Product Change Notification

Product Change Notification: E-20-009598

COVER FOR SOCKET HOUSING, 21POS.

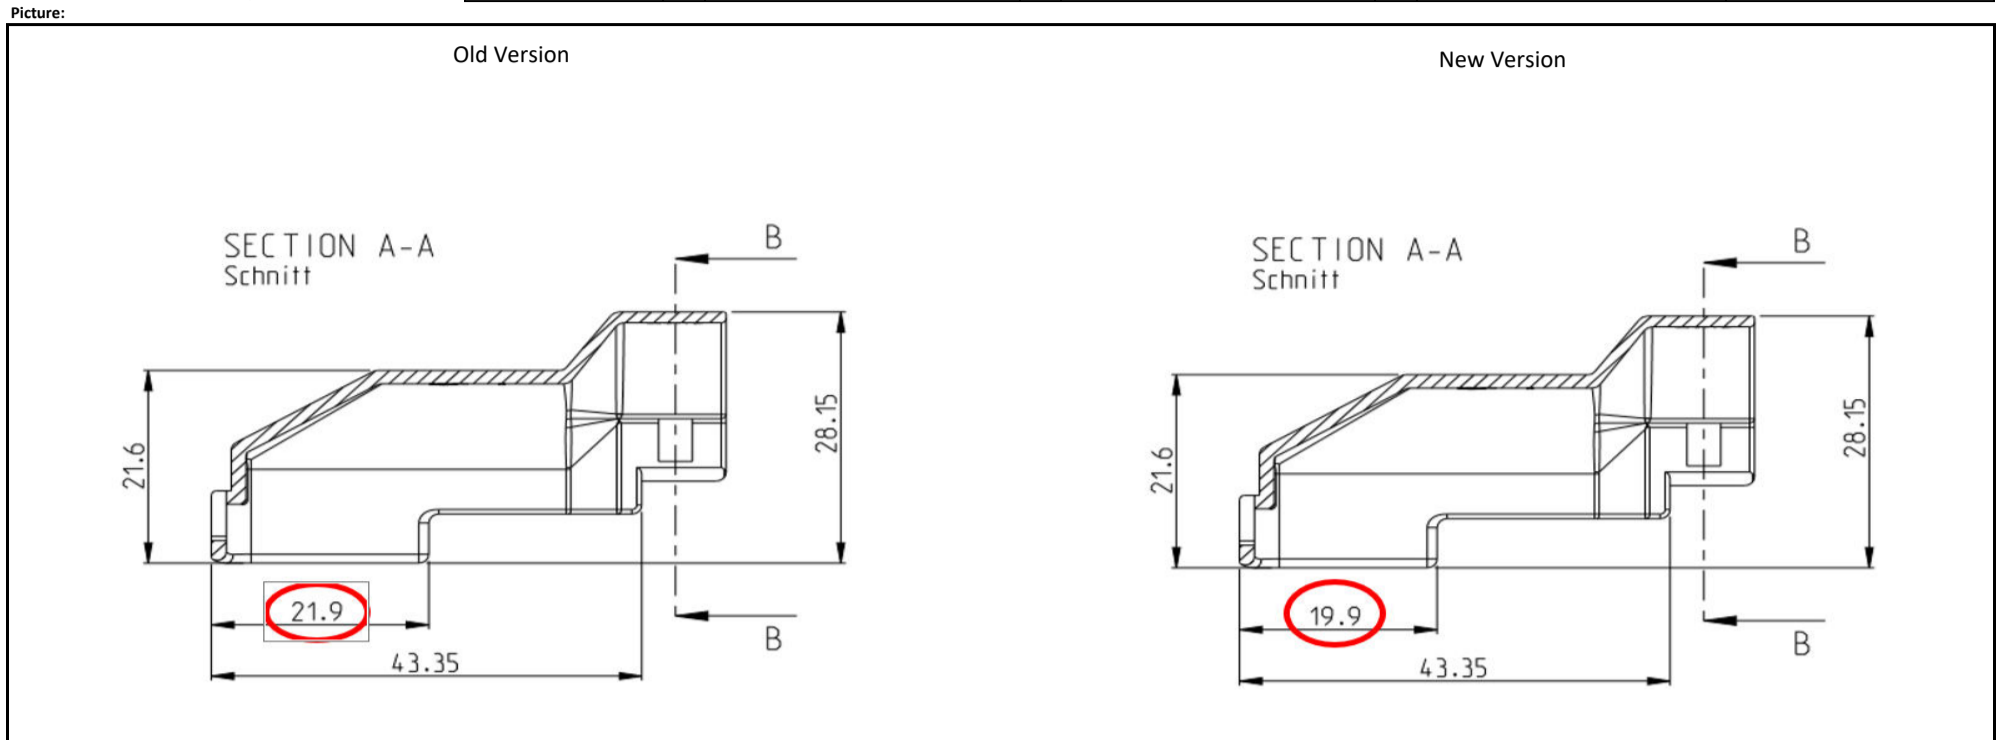
Slight change of side walls to fit cover on exiting version of 21pos Rec Hsg and new revers cable outlet version. Side wall is 2mm shorter, no change in performance. This change is considered by TE Connectivity as a Form, Fit, Function change.

<input checked="" type="checkbox"/>	Potential Impact for Customer	<input checked="" type="checkbox"/>	Product Type	<input checked="" type="checkbox"/>	Change Type	<input checked="" type="checkbox"/>	Kind of Change	<input checked="" type="checkbox"/>	Change Feature	Remark / Free text
<input checked="" type="checkbox"/>	No Customer Impact	<input checked="" type="checkbox"/>	CAPS/COVERS AND COVER ASSEMBLIES	<input checked="" type="checkbox"/>	Form, Fit, Function	<input checked="" type="checkbox"/>	Geometry	<input checked="" type="checkbox"/>	Special Design Feature	Slight change on cover side walls to fit cover on a second version of 21pos Rec. Housing. No change in protection performance.
